Appendix III of RNTPC Paper No. A/NE-TKL/759A

Section 16 Planning Application for Proposed Temporary Logistics Centre for a Period of 3 Years and Filling of Land and Pond at Lots 267 (Part) and 268 (Part) in D.D. 84, Lots 481 S.A (Part) and 481 RP (Part) in D.D. 87 and adjoining Government Land, Ping Che, Ta Kwu Ling, New Territories

Responses to Comments from Transport Department (A/NE-TKL/759)

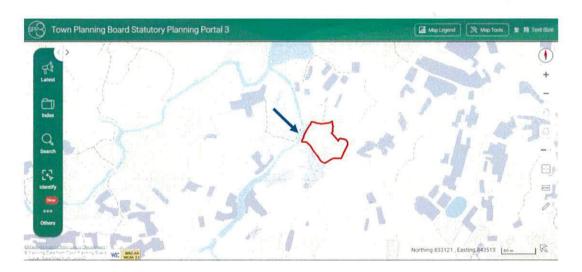
- Disturbance on natural stream: The application site is located very close to a natural stream (Figure 1). No details are available to demonstrate that no deterioration in water quality would be resulted during both construction and operation phase.
- Potential adverse drainage impact: No sufficient details are available to demonstrate that drainage impact would be properly handled. We worry that filling of land and some other watercourses would largely change the hydrology of the site, and such change would affect the adjacent uses.

Existing drainage features within the subject site

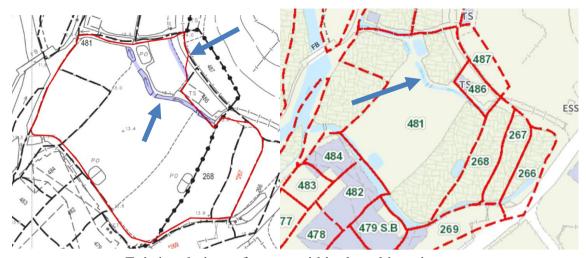
- Section 2.4 The applicant should maintain or channelise the existing stream course within the development area rather than filling it. Alternatively, the applicant may consider to provide intake point and supporting drainage facilities to intercept the flow from the existing stream course;

Drainage Proposal

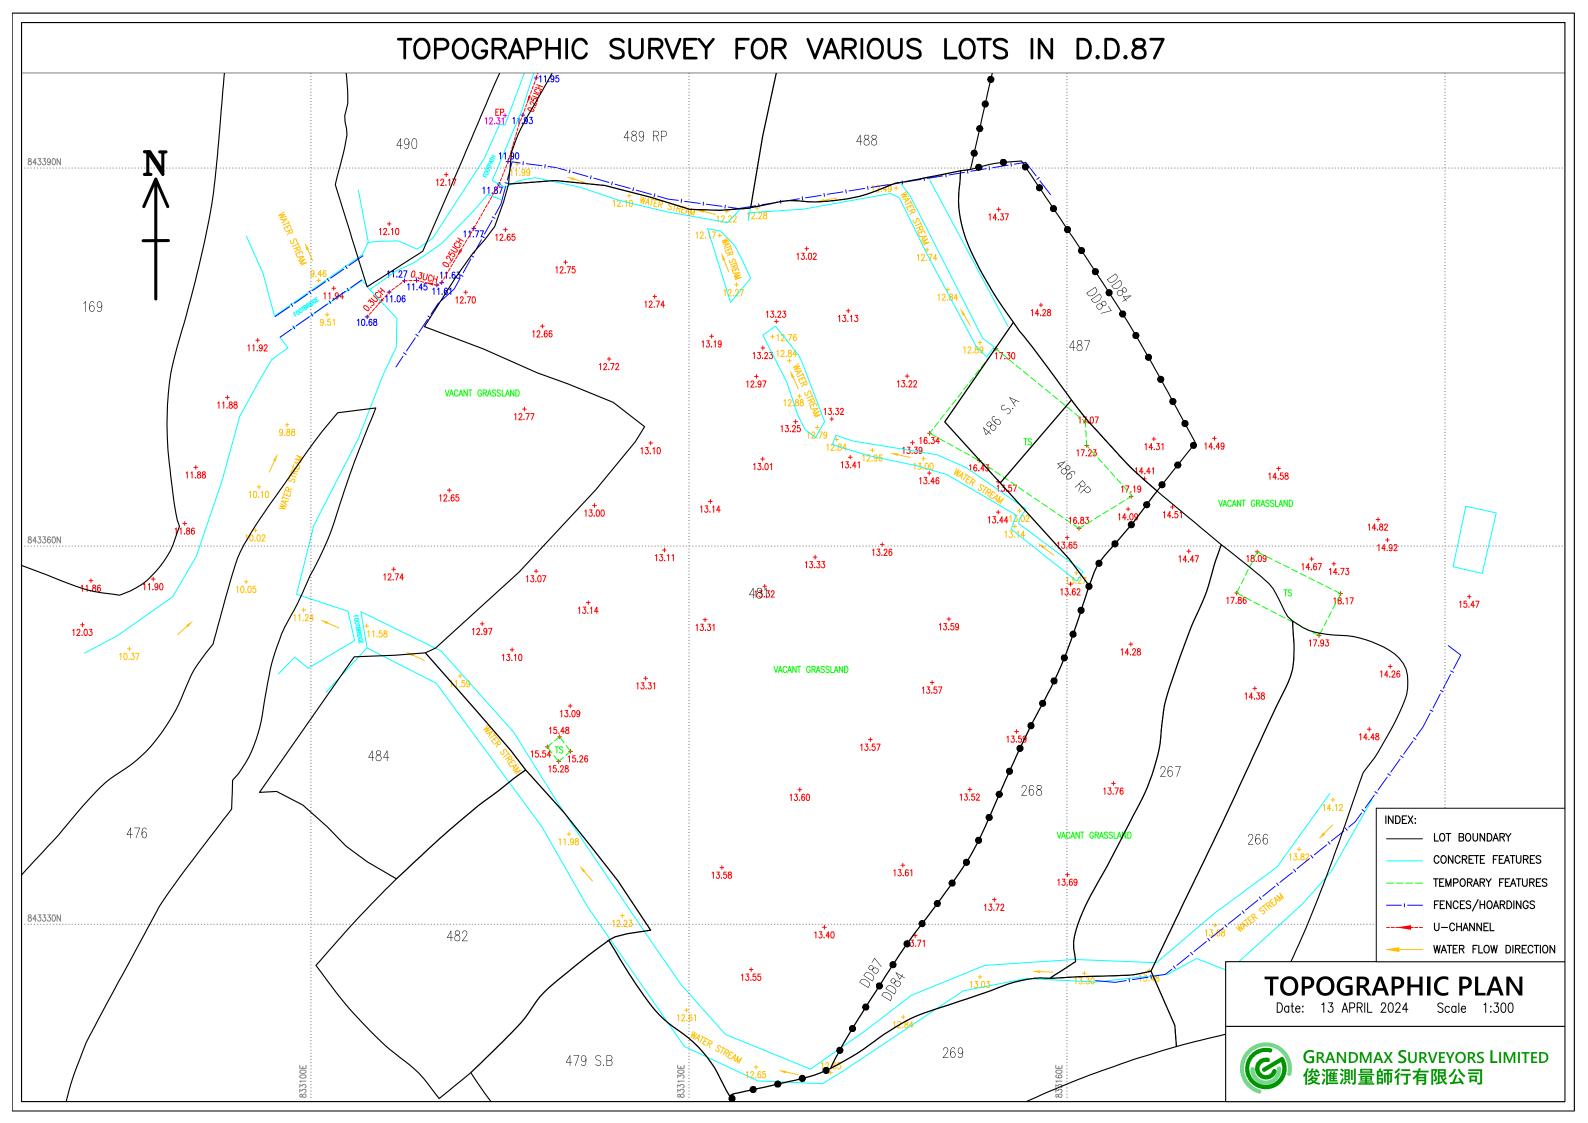
- (iv) her detailed comments on the submitted drainage proposal are as follows:
 - the applicant should verify if Appendix D matches with the filling plan shown on Section 3.4. The applicant should indicate the clearance with the existing stream course in Appendix D;

- Appendix D The applicant should provide details of discharge path and indicate the catchpits with sand trap;
- (g) to note the comments of the Director of Fire Services (D of FS) that:

Calculation of Capacity of Existing Stream Course at Section A-A

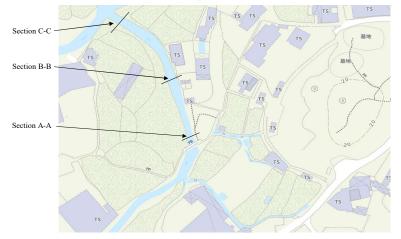
Appendix C Downstream Capacity Checking - The data listed (as captured below) seems to be the site areas rather than the surface runoff, the applicant should clarify and review the calculation accordingly; and
